**ATLANTIC
ENGINEERING
SERVICES**

Re: Additional Testing
Glynn Archer School / City Hall Conversion
Key West, Florida

Project: #312-295

EX1
 1 OF 6

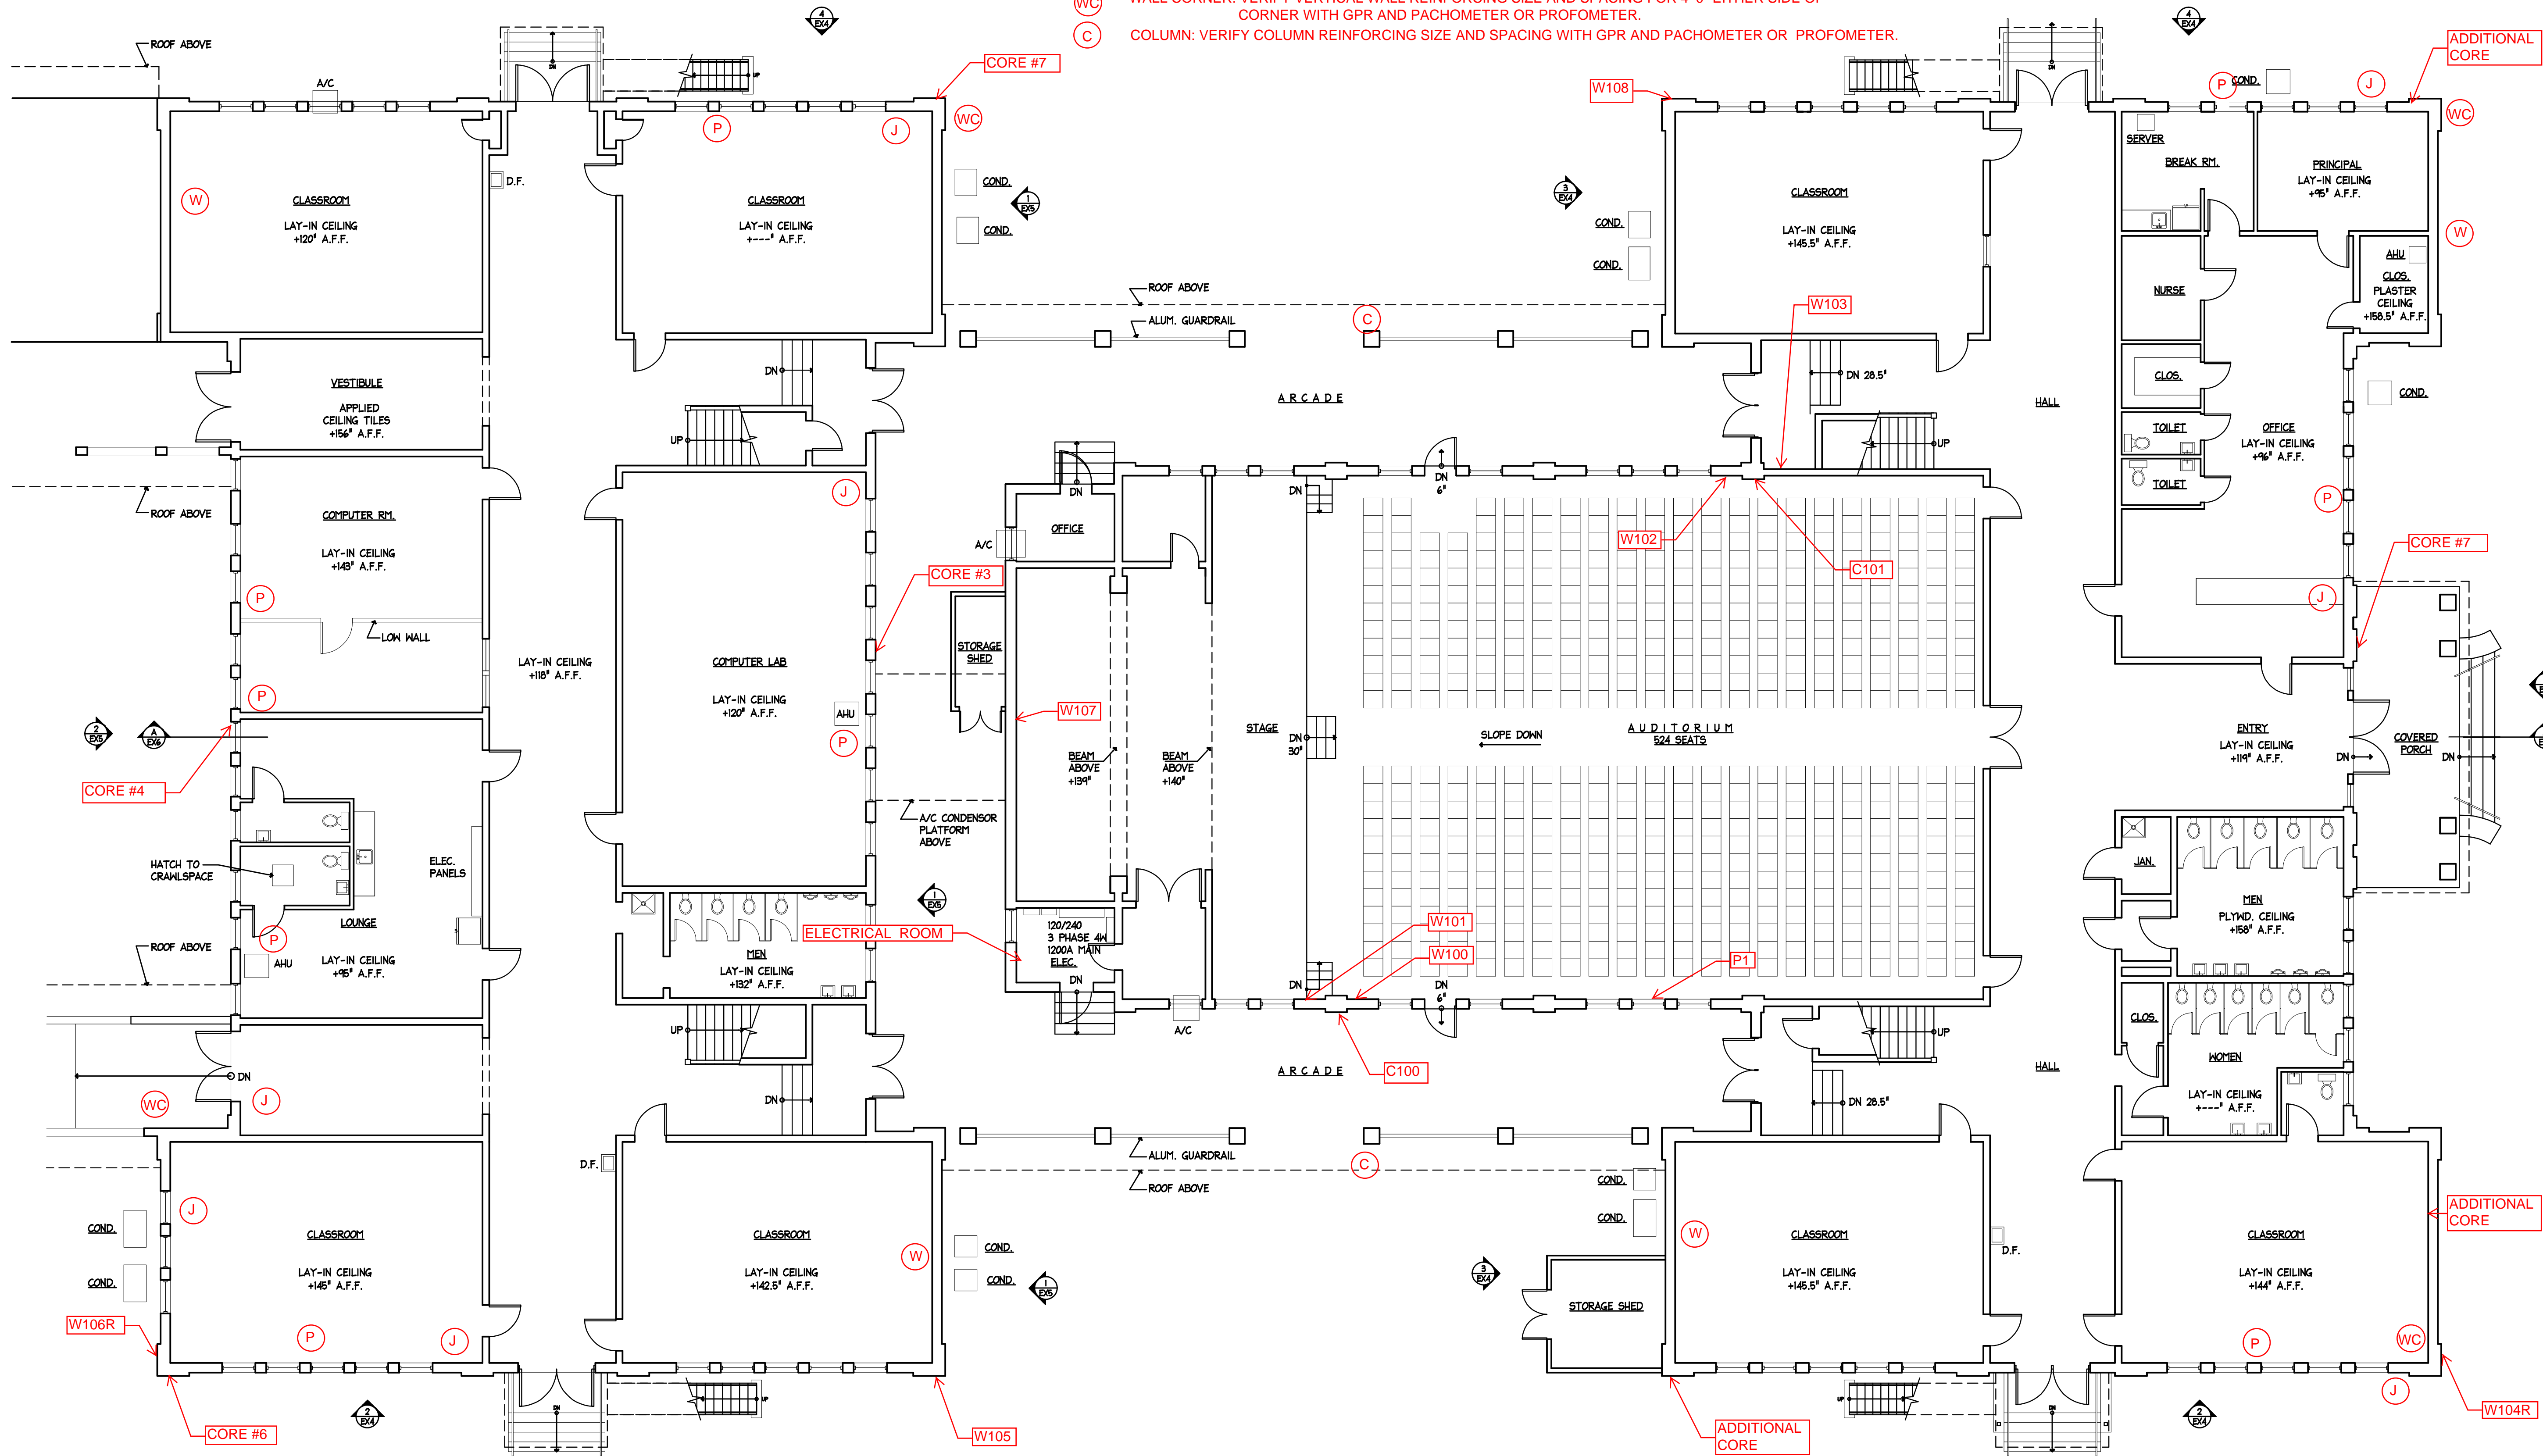
- (J) JAMB: VERIFY JAMB VERTICAL WALL REINFORCING SIZE AND SPACING FOR 4'-0" WIDTH OF WALL AT JAMB WITH GPR AND PACHOMETER OR PROFOMETER.
- (P) PILASTER: VERIFY PILASTER REINFORCING SIZE AND SPACING WITH GPR AND PACHOMETER OR PROFOMETER.
- (W) WALL: VERIFY VERTICAL WALL REINFORCING SIZE AND SPACING FOR 6'-0" WIDTH WITH GPR AND PACHOMETER OR PROFOMETER.
- (WC) WALL CORNER: VERIFY VERTICAL WALL REINFORCING SIZE AND SPACING FOR 4'-0" EITHER SIDE OF CORNER WITH GPR AND PACHOMETER OR PROFOMETER.
- (C) COLUMN: VERIFY COLUMN REINFORCING SIZE AND SPACING WITH GPR AND PACHOMETER OR PROFOMETER.

EX2
 2 OF 6

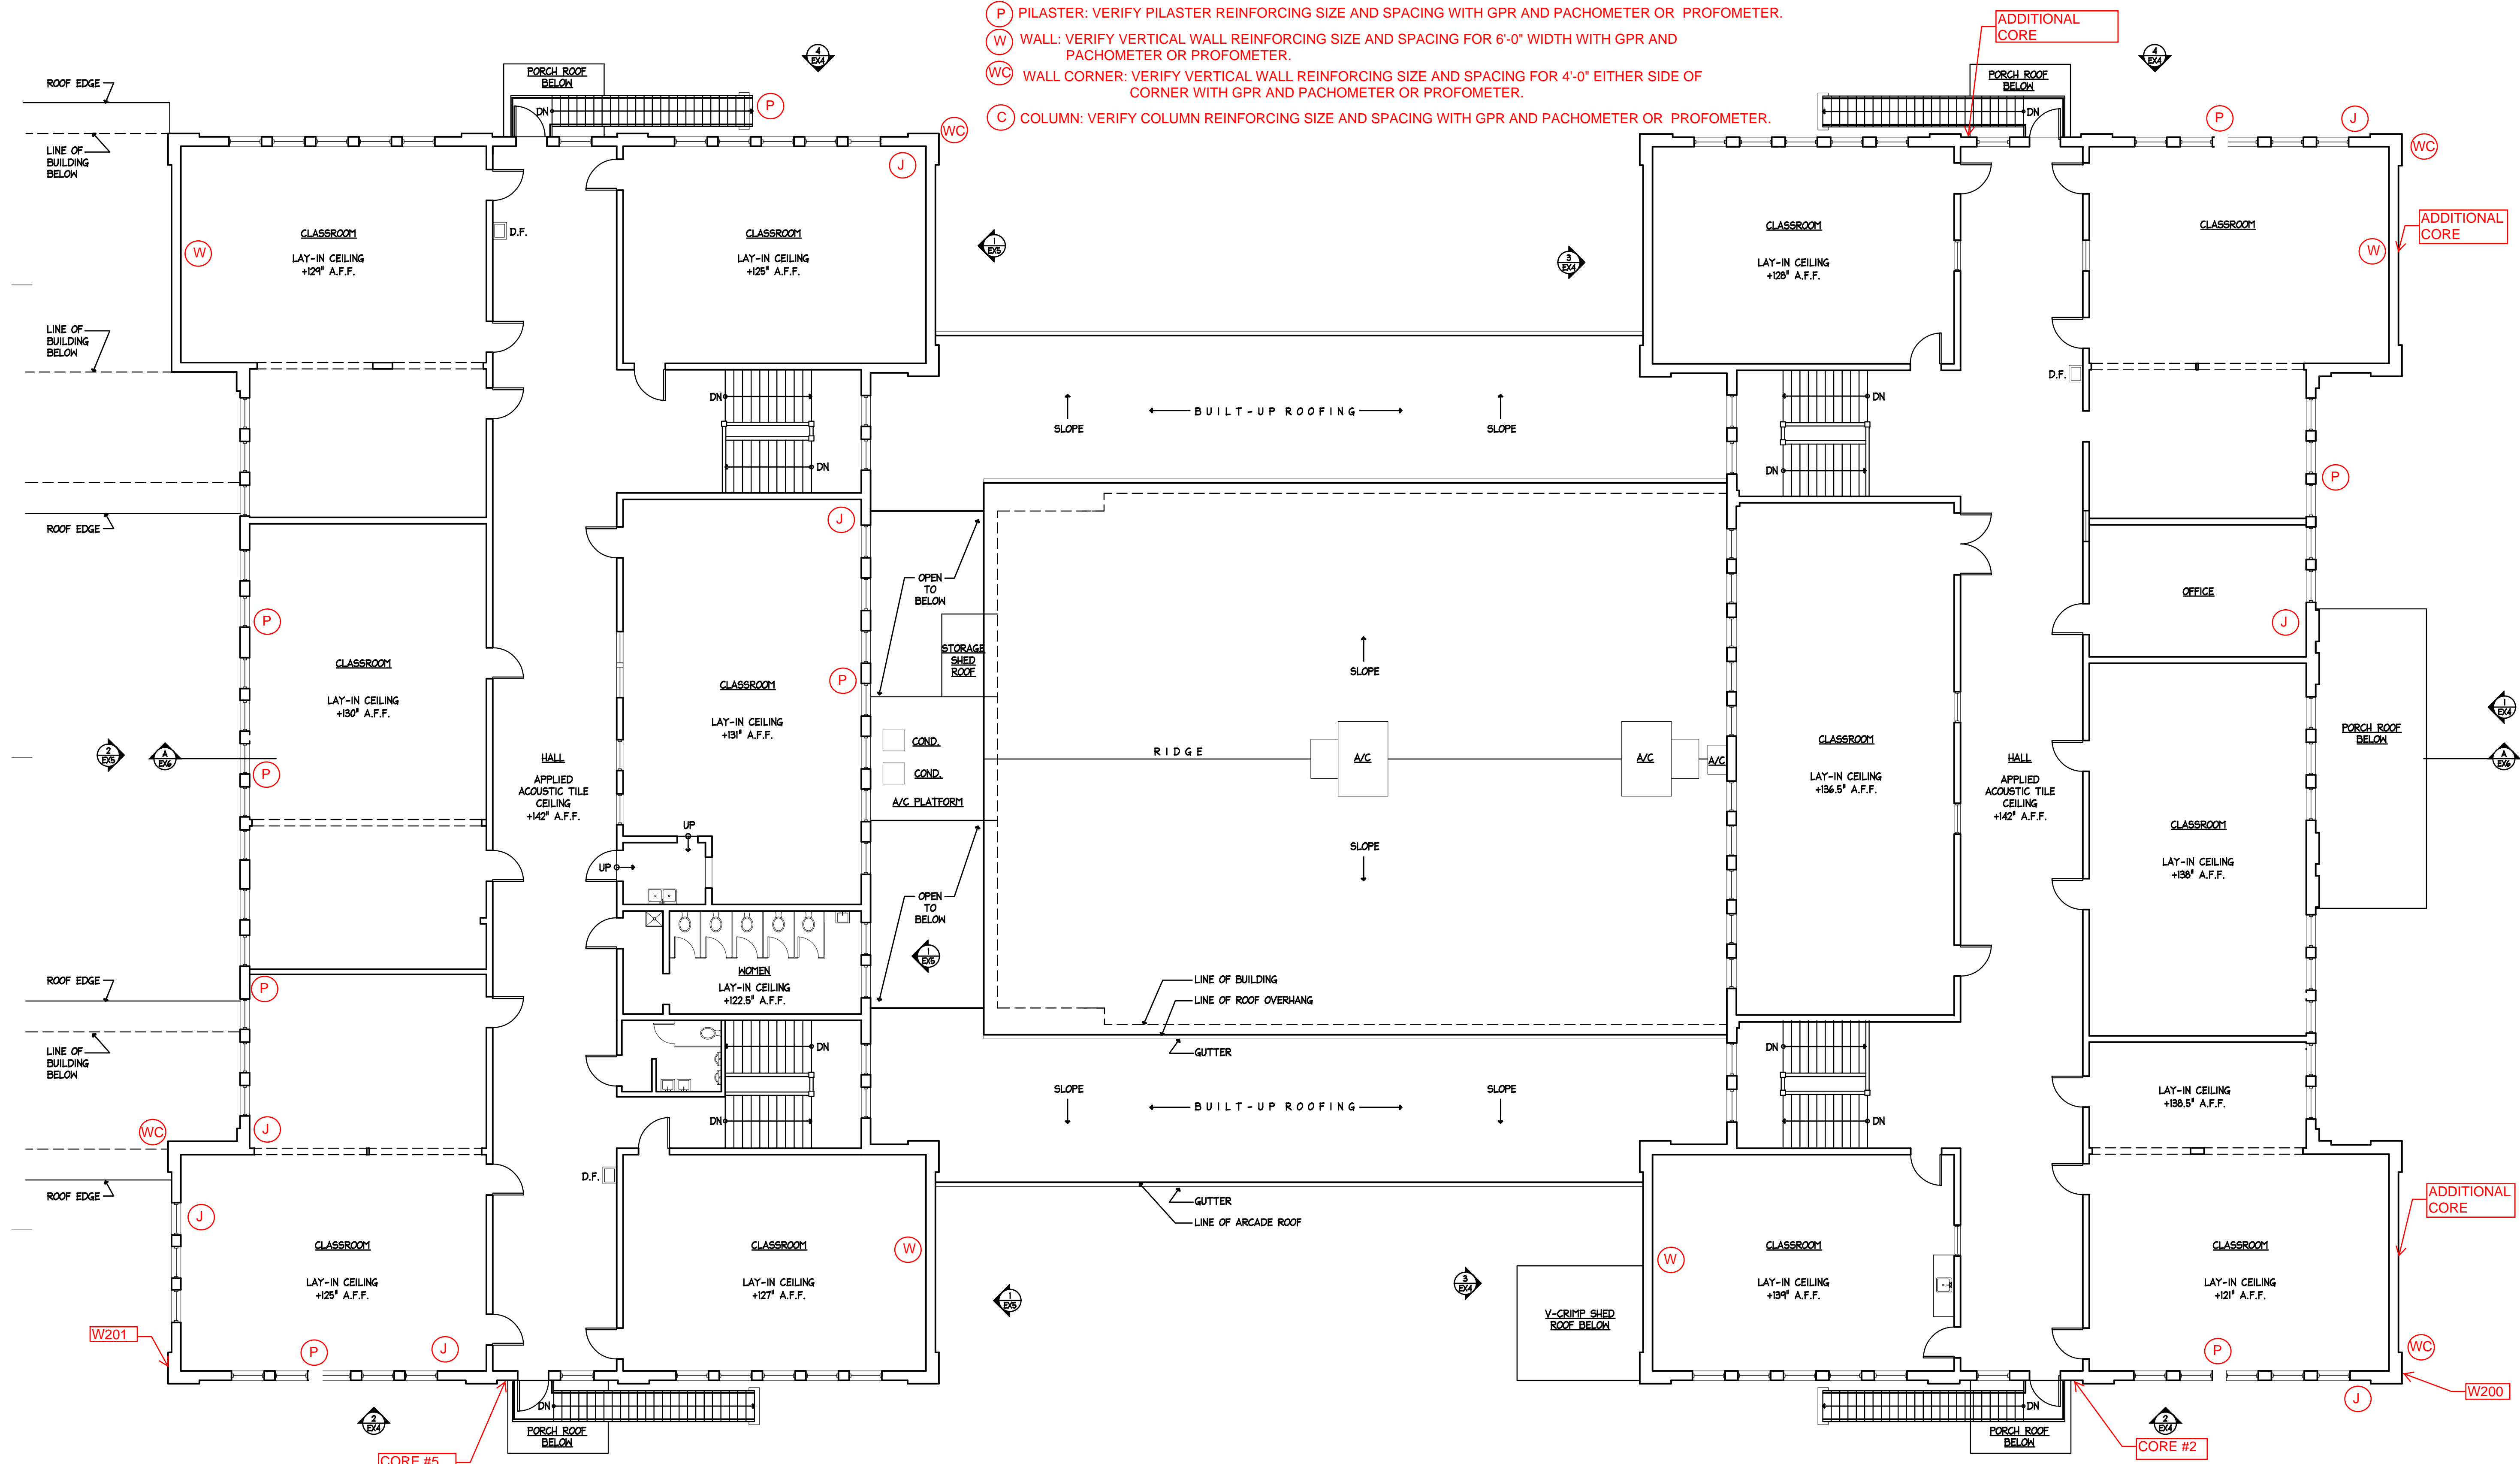
(J) JAMB: VERIFY JAMB VERTICAL WALL REINFORCING SIZE AND SPACING FOR 4'-0" WIDTH OF WALL AT JAMB WITH GPR AND PACHOMETER OR PROFOMETER.

(P) PILASTER: VERIFY PILASTER REINFORCING SIZE AND SPACING WITH GPR AND PACHOMETER OR PROFOMETER.

(W) WALL: VERIFY VERTICAL WALL REINFORCING SIZE AND SPACING FOR 6'-0" WIDTH WITH GPR AND PACHOMETER OR PROFOMETER.

(WC) WALL CORNER: VERIFY VERTICAL WALL REINFORCING SIZE AND SPACING FOR 4'-0" EITHER SIDE OF CORNER WITH GPR AND PACHOMETER OR PROFOMETER.

(C) COLUMN: VERIFY COLUMN REINFORCING SIZE AND SPACING WITH GPR AND PACHOMETER OR PROFOMETER.
